LOT 14E, BLOCK 95-A SNOW HEIGHTS
ADDITION ALBUQUERQUE, NEW MEXICO

DRAINAGE AND GRADING PLAN

PEREAS RESTAURANT

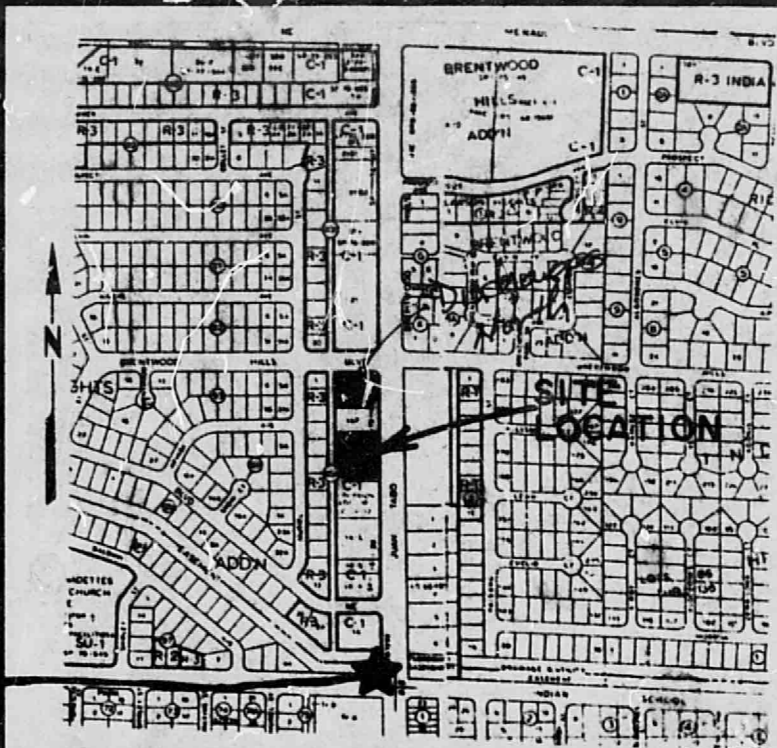
show proposed alley HYDRAULICS along the alley and not affected
 $Q = CLH^{3/2}$

12/27/85
Roger L. Brown, P.E. Hydrologist
ADVISE OF NAGY INSPECTOR WHEN GRADING BEGINS

To reduce the frequency of runoff from this site into the alley, a small (665 cu. ft.) retention pond is proposed. This minor volume will have no impact on major flows and it is not considered in the design of the weir and runoff. From be positive outlet
